Access Compliance Report

Public Rights-of-Way

(Curb Ramps)

Intersection ID: 16671	Main Street: RANDOLPH_RD	Cross Street: WENDWOOD_LN	Location: NW
ADA ID: 940D88621D19	Ramp Type: PerpDiag	Initial Pass/Fail: Fail	Overall Compliance: No
Severity Score: 25			
Codes/Mitigation Info/Possible Solution		Field Measurements/Component Compliance

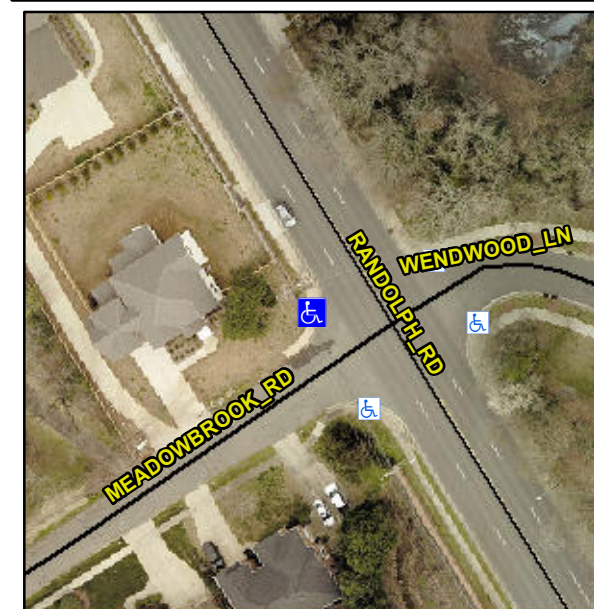
R304.2.2, R304.5.3

Compliance	Description	Data	Compliance	Description	Data
N/A	Ramp Length (in)	49.0	No	Ramp Slope (%)	11.1
Yes	Ramp Width (in)	48.0	No	Ramp XSlope (%)	5.4
N/A	Flare Type LT	N/A	N/A	Flare Type RT	N/A
N/A	Flare Slope LT (%)	N/A	N/A	Flare Slope RT (%)	N/A
N/A	Flare Traversable LT?	N/A	N/A	Flare Traversable RT?	N/A
N/A	Landing Length (in)	N/A	N/A	DWS Provided?	N/A
N/A	Landing Width (in)	N/A	N/A	DWS Contrast?	N/A
N/A	Landing Slope (%)	N/A	N/A	DWS Length (in)	N/A
N/A	Landing X Slope (%)	N/A	N/A	DWS Full Width?	N/A
N/A	Landing Curb? (Y/N)	N/A	N/A	DWS Offset (in)	N/A
N/A	Shared Landing?	N/A			
N/A	Gutter Ponding?	N/A	N/A	Gutter Slope (%)	N/A
N/A	Gutter Lip Ht (in)	N/A	N/A	Gutter X Slope (%)	N/A
N/A	Painted X Walk1?	No	N/A	Painted X Walk2?	No
	X Walk 1 Direction	To SE		X Walk 2 Direction	To NE
N/A	X Walk 1 Width (in)	N/A	N/A	X Walk 2 Width (in)	N/A
	X Walk 1 Slope (%)	5.0		X Walk 2 Slope (%)	7.0
	X Walk 1 X Slope (%)	6.7		X Walk 2 X Slope (%)	1.0

Remove & Replace Curb Ramp With Two New Directional Ramps or Equivalent.
